Intermodal Logistics Centre at Enfield

Modification Application No. 6 ECI Detailed Design Adjustments and Subdivision

Response to Submissions

Appendix A:
Submissions

Figure 3 Northern barrier - Updated

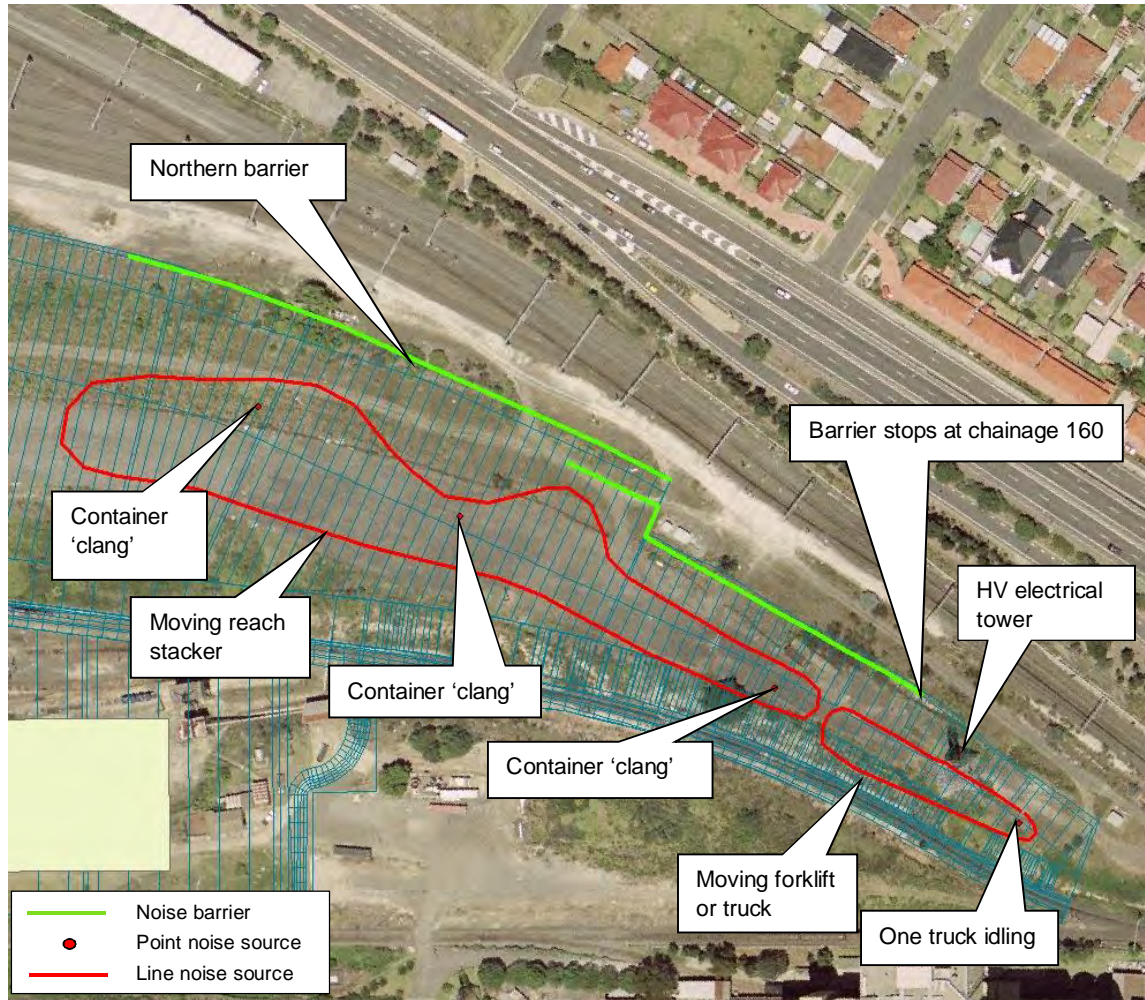
Shortening of the Northern Noise Wall

The EPA notes that barrier optimisation modelling has been undertaken (Appendix A: Acoustic Memo), however sufficient detail has not been provided to enable the EPA to conduct a thorough review of the model. The Acoustic Memo indicates that previously predicted noise levels will not increase with the proposed changes to the noise barriers.

The EPA also notes that the proponent states that container handling will not be undertaken in the area surrounding the high voltage power line tower, but that this area is still included within the 'Empty Container Storage Area B' shown on Figure 3 of the Modification Application documents, and will be included as part of the lease for the Empty Container Storage Area B (page 13). The EPA is therefore concerned that there are currently no measures in place that will ensure that the area surrounding the high voltage tower will not be used for container handling or other noisy activities.

The EPA recommends that if the Project Modification Application is approved, the conditions of approval regarding noise limits remain unchanged. The EPA also recommends that any approval for the proposal also include a condition stating that container handling may not be undertaken in the area that will be affected by the removal of the noise wall. The EPA recommends that this area be marked on a map and referenced in this condition.
